**DEPARTMENT OF PLANNING AND COMMUNITY DEVELOPMENT**

**CASE NOS.:** 07-SPR-012, 07-VAR-003, 07-SP-024 &  
TPM 70808 (Ref: 05-VAR-007)

**LOCATION:** 29338 Roadside Drive  
(A.P.N. 2061-004-038, 039 and 027)

**REQUEST:** Request for a Site Plan/Architectural review to replace a self-serve car wash and lube/smog-check facility with a new 4,169 square-foot car wash, lube and smog check facility; a Tentative Parcel Map to adjust lot lines of three parcels for the proposed construction; a Sign Permit for the facility signage; and a Variance from Zoning Ordinance Sections 9383.4, 9606.2.E and 9383.1 to provide a 7.5-foot rear (south) yard building setback instead of at least 20 feet, to construct a 13-foot high retaining wall instead of a maximum height of 6 feet, and to provide for a parcel smaller than the minimum requirement of three acres.

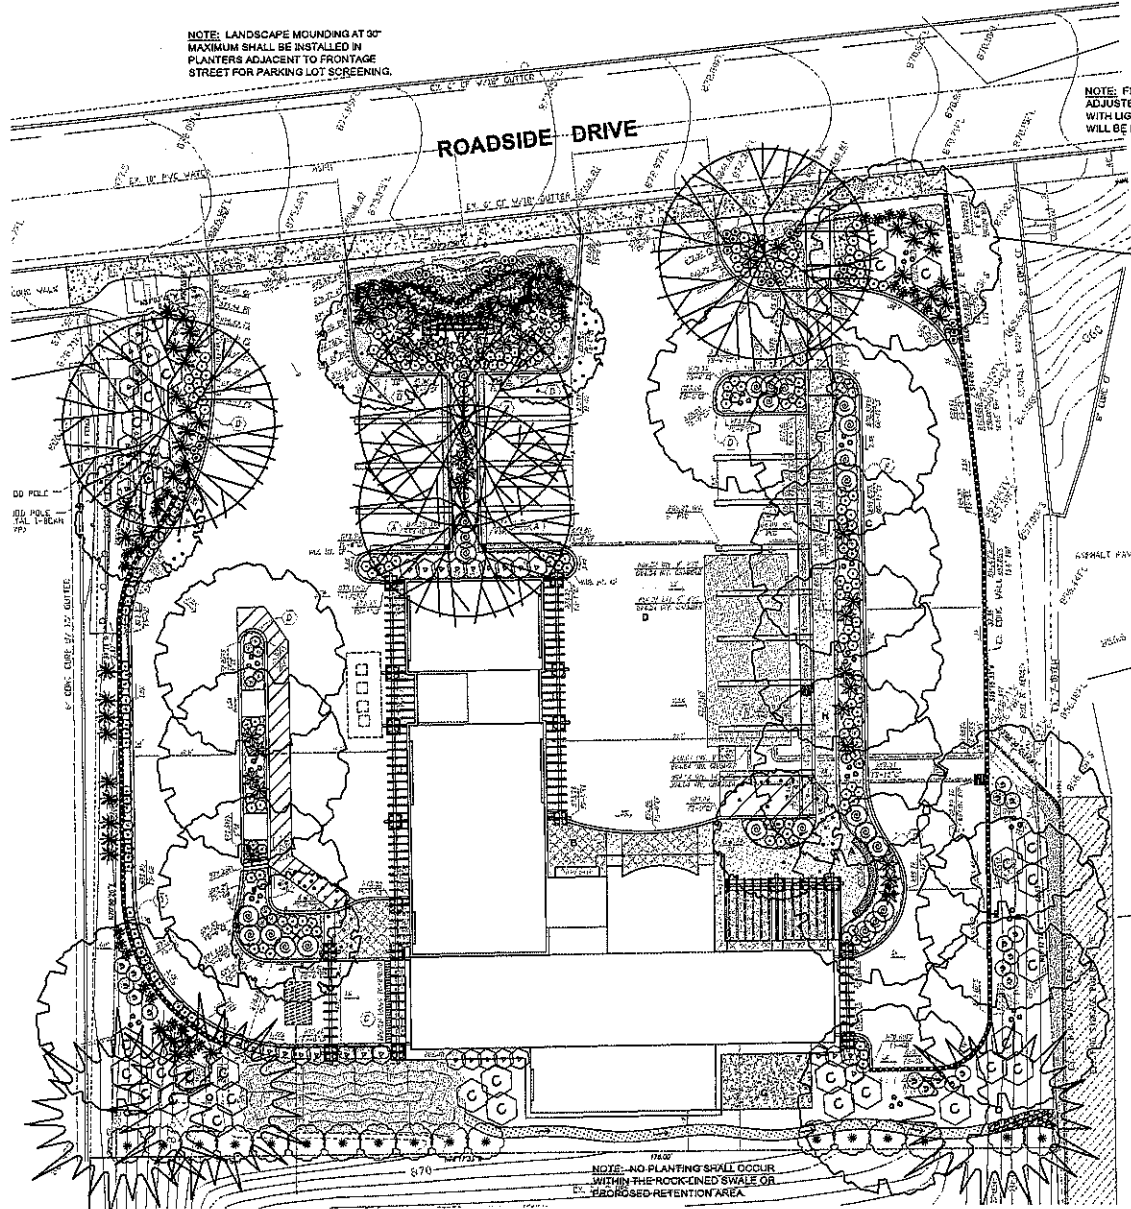
46. Since the front planter at the east side of the site along Roadside Drive is less than 20' deep as required by the Municipal Code, the final landscape plan shall ensure that proper screening is provided through the use of plant material and landscape berming to the satisfaction of the City Landscape Consultant.

53. Vines shall be used to soften proposed retaining walls and columns.
54. The four and one-half foot (4-1/2') wide planters west of the building are too narrow for the proposed *Quercus agrifolia*. Another tree shall be selected for this planter that satisfies the City Landscape Consultant.

56. The Planting Plan shows a two foot (2') wide rock-lined swale near the south property line; however the most recent Grading Plan now shows this as a grass bioswale and was not shown in any form on the Architectural Site Plan. These discrepancies must be coordinated in all of the final working drawings.
